ROCHESTER PUBLIC WORKS DEPARTMENT

TRANSMITTAL LETTER NO.: (24-01)

STANDARD SPECIFICATIONS BOOK

SUBJECT: Sewer Specifications S100, Watermain Specifications W200, Service Connections C150, Engineering Standards

DEPARTMENT OF PUBLIC WORKS CITY OF ROCHESTER, MINNESOTA			
SERVICE CONNECTIONS STUBBED INTO PROPERTY			
 CITY ENGINEER			
SHT 1 OF 3 SHTS	DATE REVISED 1/26/24	PLATE NO. 4-01	REV. J

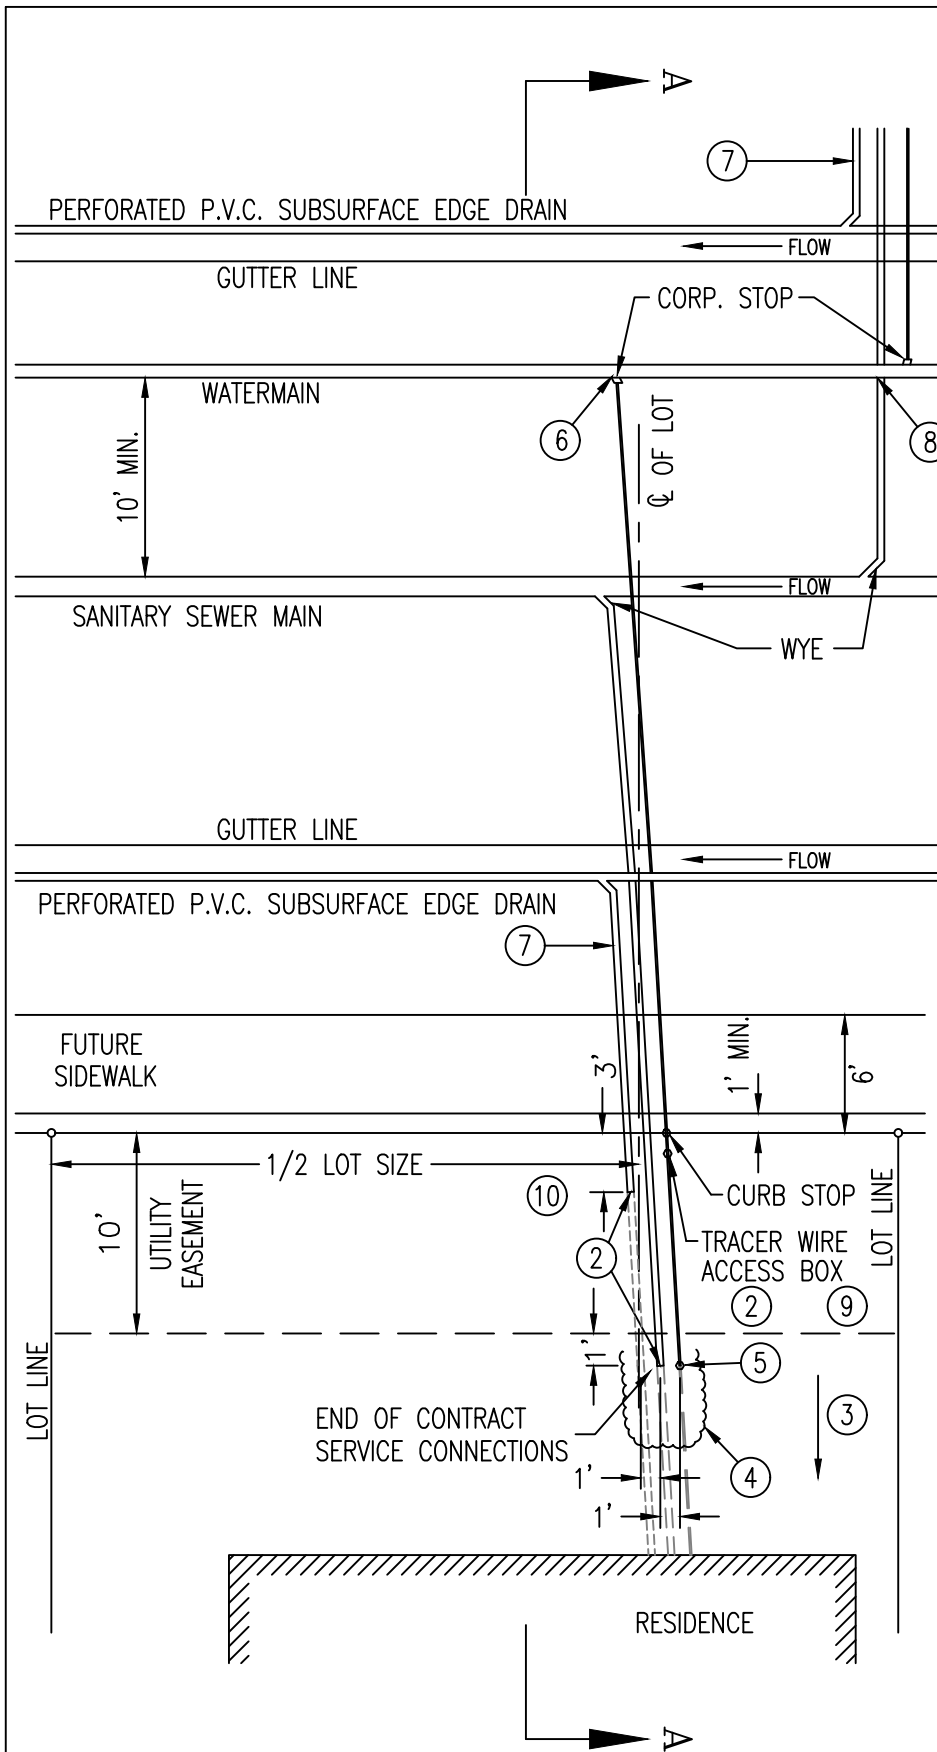
- 4-01J** Added dimension and “NOTE 10” to call out ending subsurface edge drain service line 3’ past property line
Page 1
- 4-01J** Added dimension to call out ending subsurface edge drain service line 3’ past property line, changed subsurface edge drain service to show gravity flow from end of service
Page 2

DEPARTMENT OF PUBLIC WORKS CITY OF ROCHESTER, MINNESOTA SECTION A-A WORK OUTSIDE R/W & EASEMENT			
 CITY ENGINEER			
SHT 3 OF 3 SHTS	DATE REVISED 1/26/24	PLATE NO. 4-01	REV. J

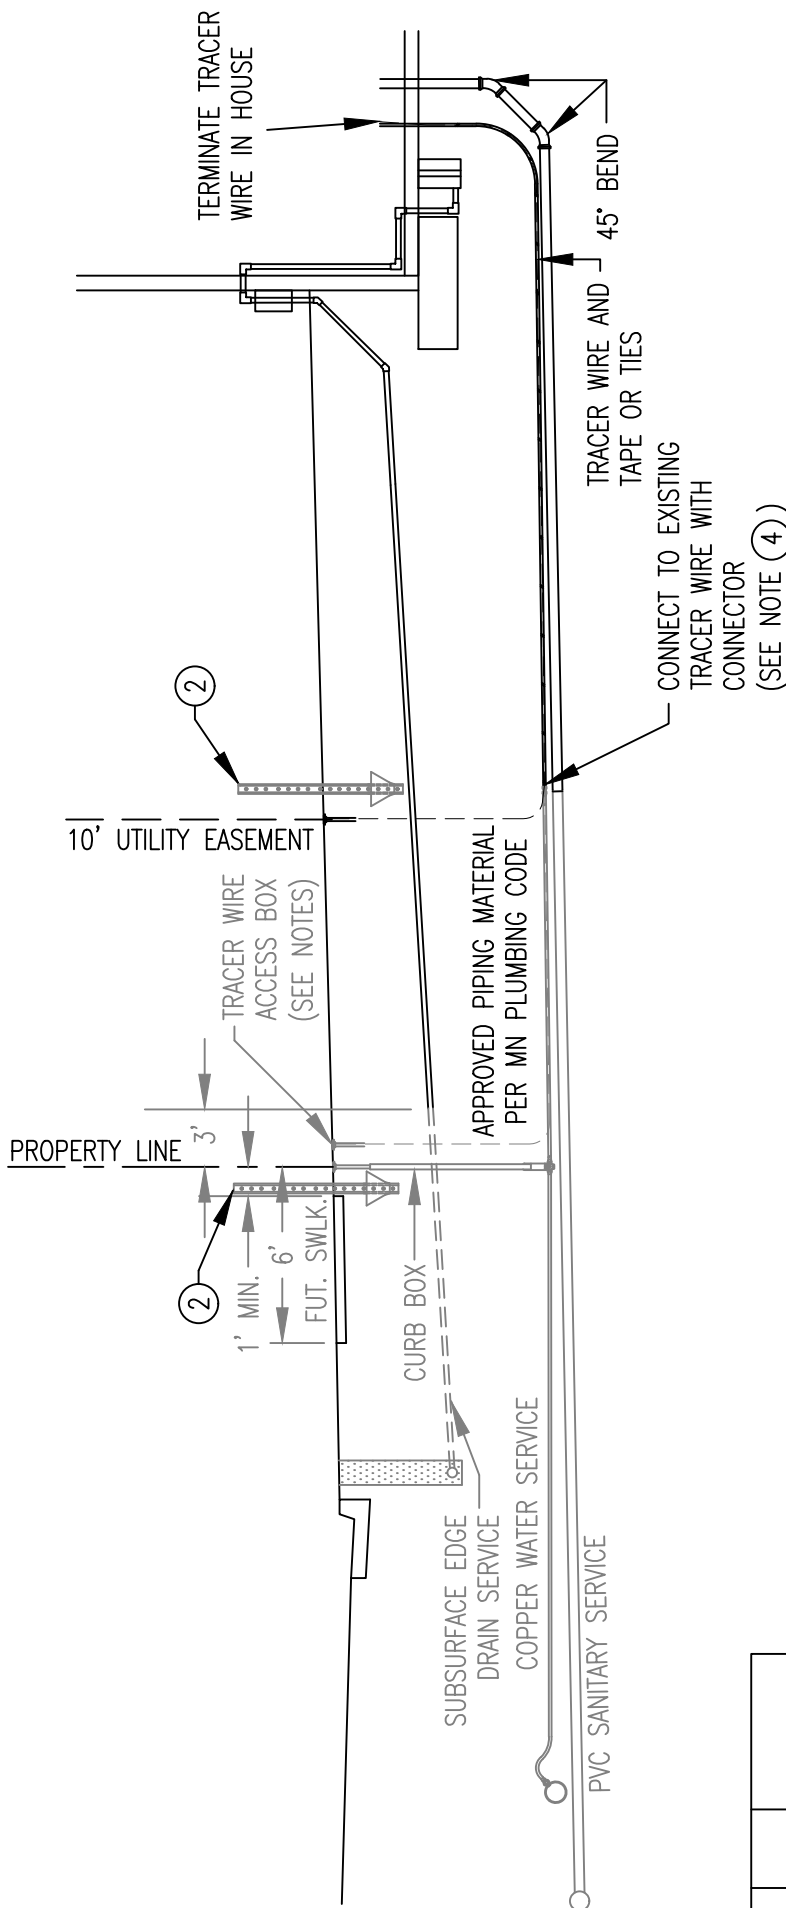
- 4-01J** Added dimension to call out ending subsurface edge drain service line 3’ past property line, changed subsurface edge drain service to show gravity flow from end of service
Page 3

DEPARTMENT OF PUBLIC WORKS CITY OF ROCHESTER, MINNESOTA STRUCTURAL SOIL DETAIL TYPE 1			
 CITY FORESTER		 PARKS & REC DIRECTOR	
SHT 1 OF 1 SHTS	DATE REVISED 1/26/24	PLATE NO. 5-02	REV. C

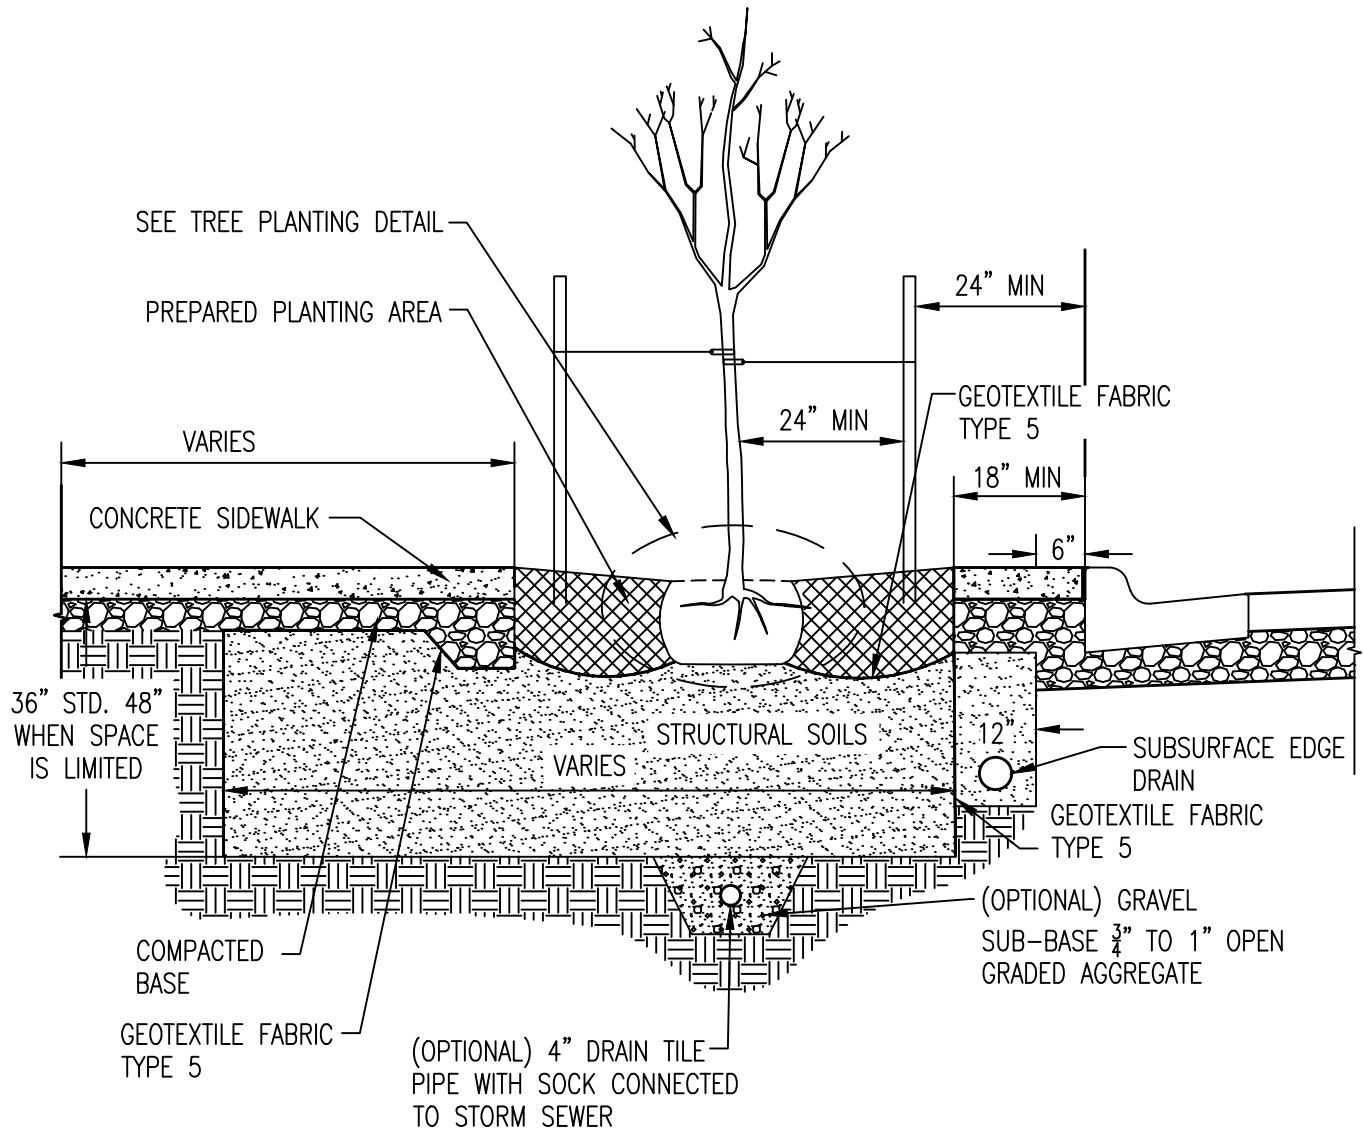
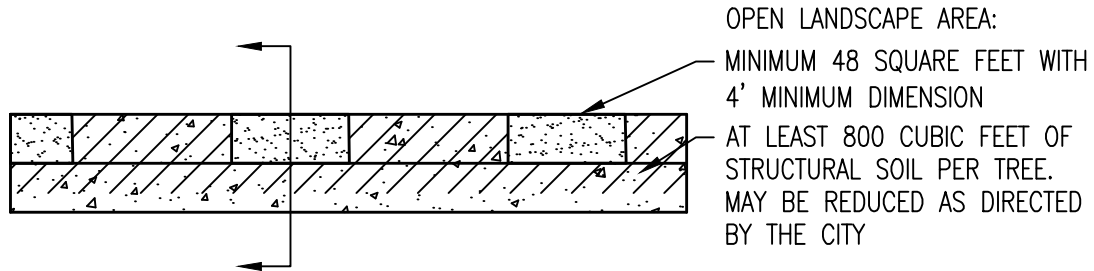
- 5-02C** Updated “NOTE 2” to reference Engineering Standards, added dimensions and subsurface edge drain to detail
- 6-13E** Added “LOT LINE” label to all lines in detail, added note “OUTLOT OR A RECORDED PRIVATE UTILITY EASEMENT” to detail, updated notes and numbered

SHT 1 OF 1 SHTS	DATE REVISED 1/26/24	PLATE NO. 6-19	REV. F
-----------------	-------------------------	-------------------	-----------

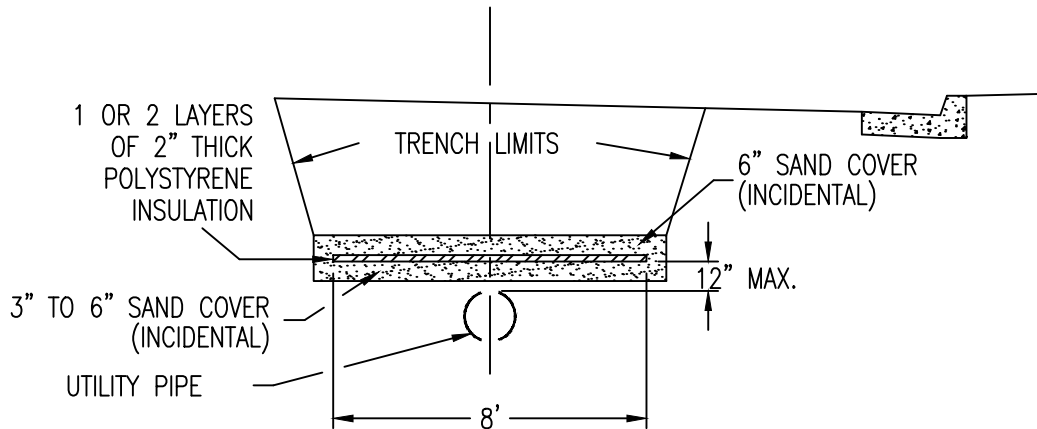
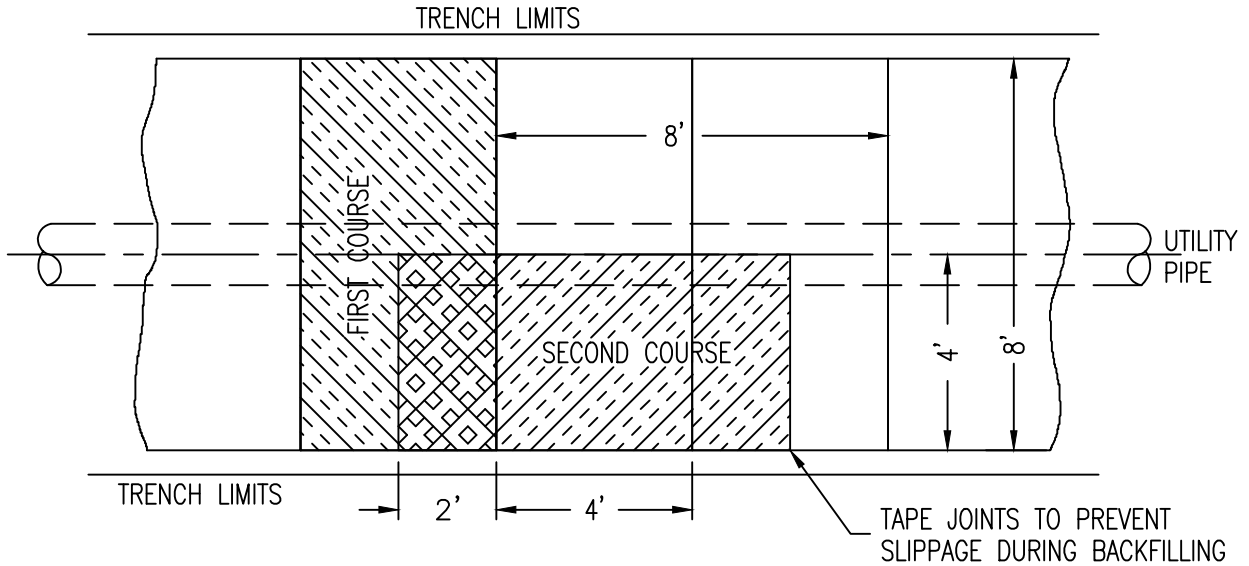
- 6-19F** Updated “NOTE 1” to include AASHTO M 230 and insulation board specifications

SHT 1 OF 5 SHTS	DATE REVISED 1/26/24	PLATE NO. 8-01	REV. D
-----------------	-------------------------	-------------------	-----------

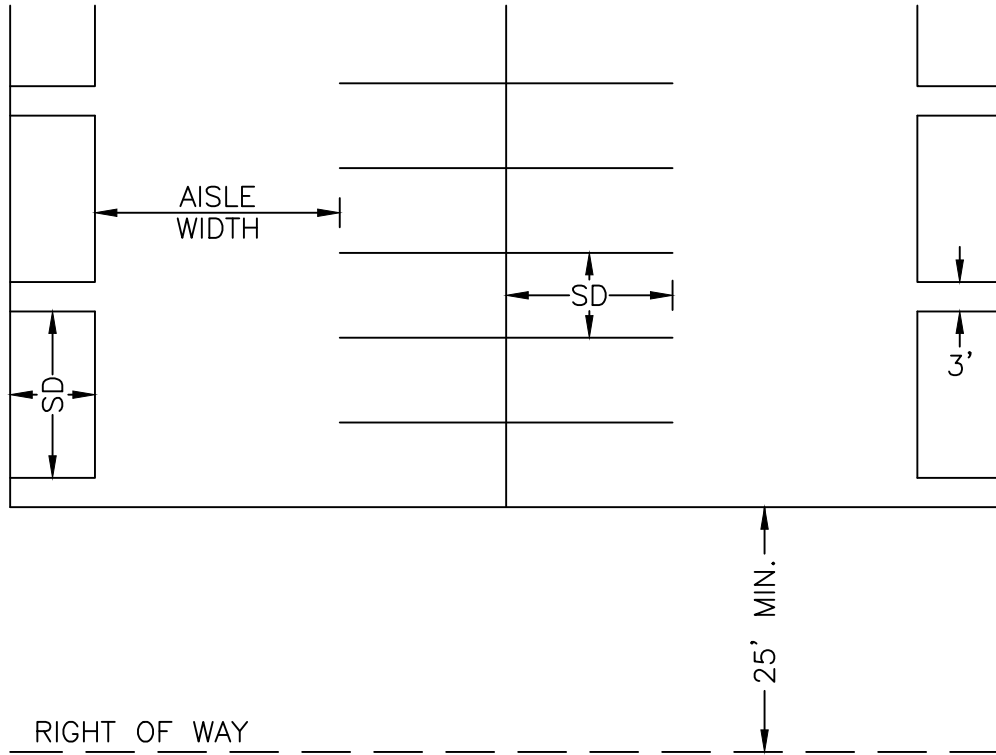
8-01D Updated “STALL DIMENSIONS (SD)” table, updated “AISLE WIDTH” table
Page 1

STALL DIMENSIONS (SD)		
SIZE OF CAR	SHORT TERM	LONG TERM
SMALL	7'6"x15'0"	7'3"x15'0"
STANDARD	8'6"x18'0"	8'4"x18'0"

AISLE WIDTH										
SIZE OF CAR	ONE-WAY					TWO-WAY				
	PAR.	30°	45°	60°	90°	PAR.	30°	45°	60°	90°
SMALL	8'	8'	10'	12'	15'	14'	14'	16'	18'	18'
STANDARD	10'	11'	12'	13.5'	20'	21'	20'	20'	21'	23'

SHT 2 OF 5 SHTS	DATE REVISED 1/26/24	PLATE NO. 8-01	REV. D
-----------------	-------------------------	-------------------	-----------

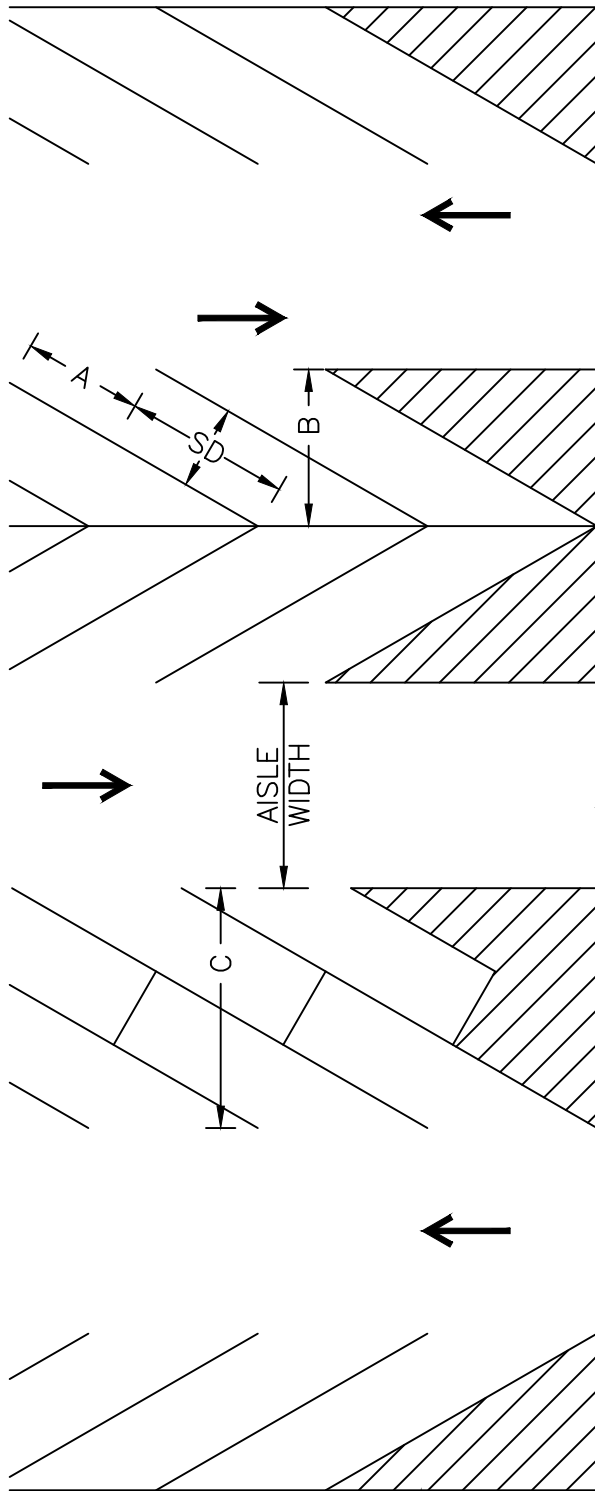
8-01D Updated “STALL DIMENSIONS (SD)” table, updated “AISLE WIDTH” table
Page 2

STALL DIMENSIONS (SD)				
SIZE OF CAR	SHORT TERM	A	B	C
SMALL	7'6"x15'0"	12'11"	15'0"	21'6"
STANDARD	8'6"x15'0"	15'0"	15'0"	22'6"
	LONG TERM			
SMALL	7'3"x15'0"	12'7"	13'9"	21'3"
STANDARD	8'4"x15'0"	14'5"	15'9"	24'3"

SHT 3 OF 5 SHTS	DATE REVISED 1/26/24	PLATE NO. 8-01	REV. D
-----------------	-------------------------	-------------------	-----------

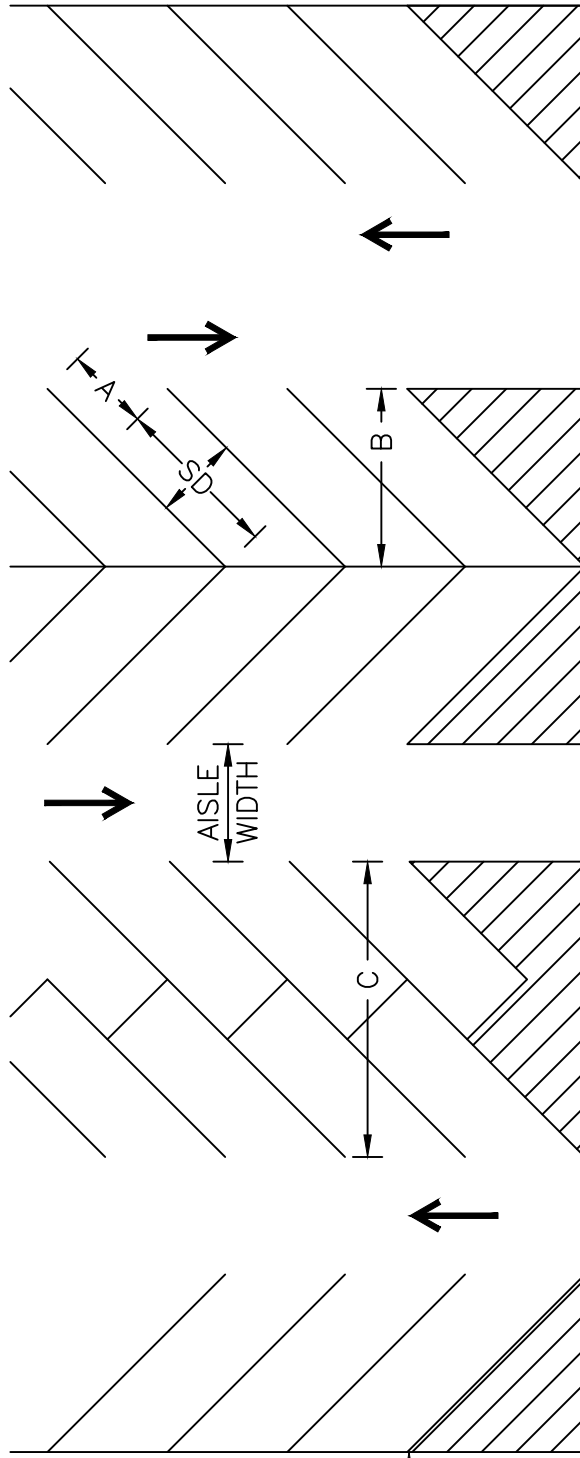
8-01D Updated “STALL DIMENSIONS (SD)” table, updated “AISLE WIDTH” table
Page 3

STALL DIMENSIONS (SD)				
SIZE OF CAR	SHORT TERM	A	B	C
SMALL	7'6"x15'0"	7'6"	15'11"	26'6"
STANDARD	8'6"x17'7"	8'6"	17'7"	29'2"
	LONG TERM			
SMALL	7'3"x15'0"	7'3"	15'9"	26'4"
STANDARD	8'4"x17'0"	8'4"	17'11"	29'11"

SHT 4 OF 5 SHTS	DATE REVISED 1/26/24	PLATE NO. 8-01	REV. D
-----------------	-------------------------	-------------------	-----------

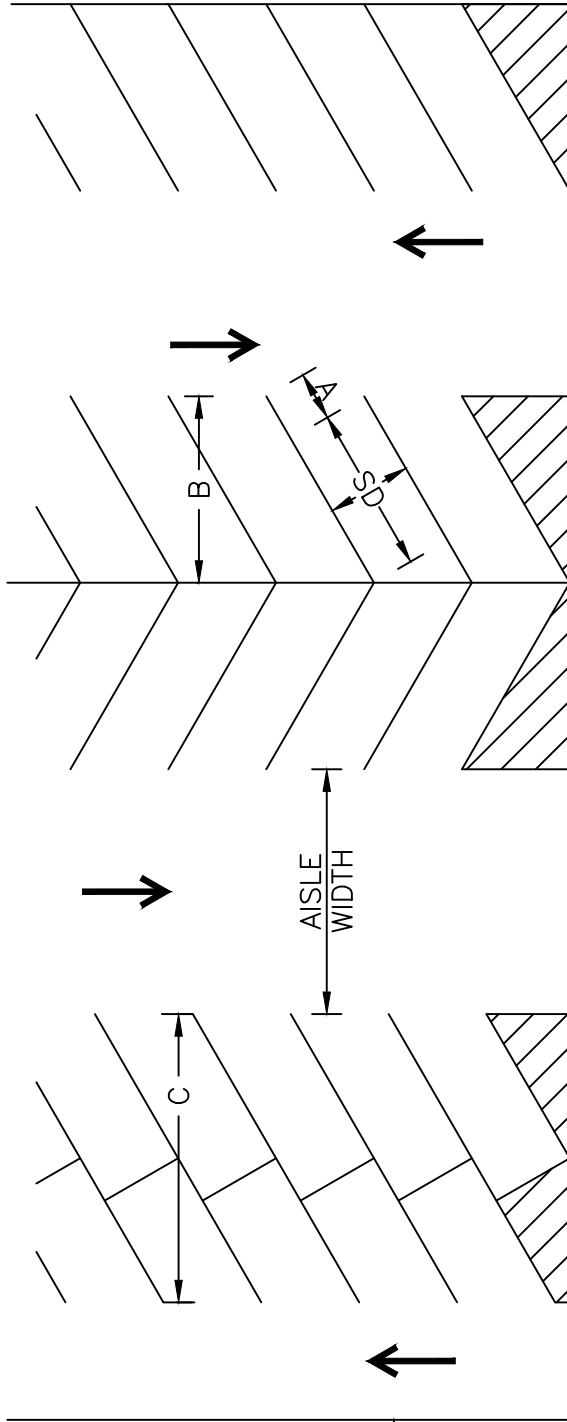
8-01D Updated “STALL DIMENSIONS (SD)” table, updated “AISLE WIDTH” table
Page 4

STALL DIMENSIONS (SD)				
SIZE OF CAR	SHORT TERM	A	B	C
SMALL	7'6"x15'0"	4'4"	16'9"	29'9"
STANDARD	8'6"x19'0"	4'11"	19'0"	33'9"
LONG TERM				
SMALL	7'3"x15'0"	4'2"	16'7"	29'7"
STANDARD	8'4"x17'0"	4'10"	18'11"	33'7"

SHT 5 OF 5 SHTS	DATE REVISED 1/26/24	PLATE NO. 8-01	REV. D
-----------------	-------------------------	-------------------	-----------

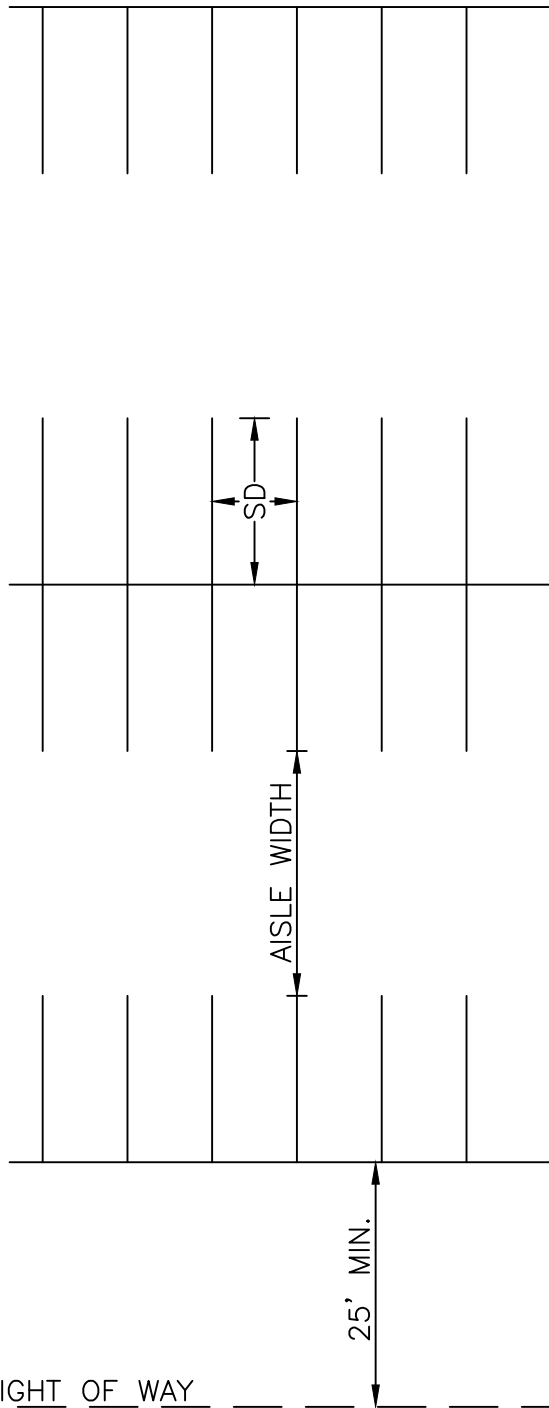
8-01D Updated “STALL DIMENSIONS (SD)” table, updated “AISLE WIDTH” table
Page 5

STALL DIMENSIONS (SD)		
SIZE OF CAR	SHORT TERM	LONG TERM
SMALL	7'6"x15'0"	7'3"x15'0"
STANDARD	8'6"x18'0"	8'4"x17'0"

AISLE WIDTH		
SIZE OF CAR	ONE-WAY	TWO-WAY
SMALL	15 FT.	18 FT.
STANDARD	20 FT.	23 FT.
